**CULTURAL RESOURCES OFFICE
 PRESERVATION BOARD
 REGULAR MEETING
 MONDAY AUGUST 26, 2013 — 4:00 P.M.
 1520 MARKET ST. #2000
www.stlouis-mo.gov/cultural-resources**

DATE: August 26, 2013
ADDRESS: 4104-56 DeTonty Street
ITEM: Preliminary Review: 16 new single family houses
JURISDICTION: Shaw Certified Local Historic District — Ward 8
STAFF: Jan Cameron, Cultural Resources Office

RECOMMENDATION:
That the Preservation Board grant an exception to the Shaw Historic District Standards and issue a preliminary approval to this proposal for new construction.

PROPOSED SOUTH ELEVATION

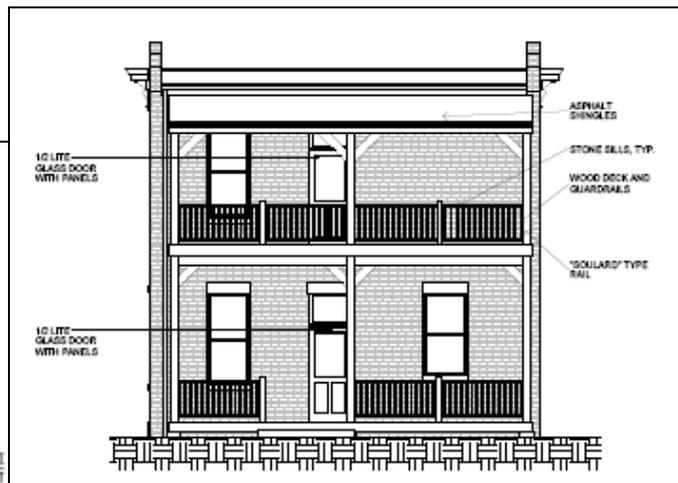
Does not comply as the interior floor levels do not align with those of the adjacent buildings.

PROPOSED GEYER AV. FACADE

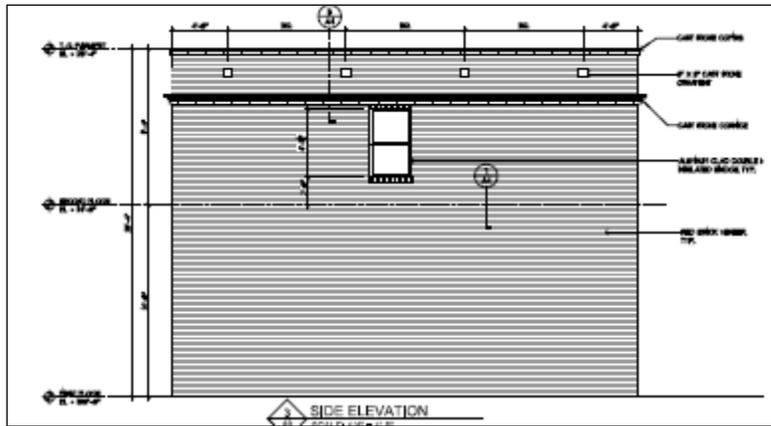
Does not comply as proposed wall is Versa-Lok, a concrete block material.

Based on these preliminary findings, the Cultural Resources Office recommends that the Preservation Board grant preliminary review approval for the proposed new construction with the stipulation that the setback and retaining wall materials are brought into compliance with the Soulard Neighborhood Local Historic District standards, and that final plans, materials and design details be approved by the Cultural Resources Office.
